1985 Corvette: Service News: Revised Differential Case Cross Pin Installation Procedure

Model and Year: 1985 Corvette **Source:** Chevrolet Service News

Date: March/April 1985 - Volume 57 - Number 2

Fig. 4 — Installing Cross Pin

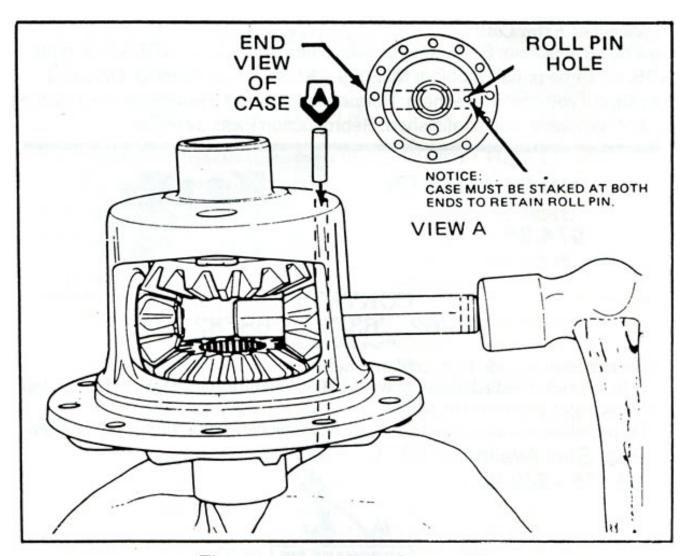
Figure 4B-39 shown on Page 4B-16 and step 10 shown on Page 4b-17 of the 1985 Corvette Shop Manual (ST-364-85) have been revised as indicated below. Fig. 4 replaces Figure 4B-39 presently shown in the Shop Manual.

10. Position the cross pin shaft in the case and drive in with a hammer. Be sure the retaining pin hole of the cross pin shaft is properly aligned to allow installation of the retaining pin. Install the retaining pin to the proper depth using a punch and stake in place at both ends of the case.
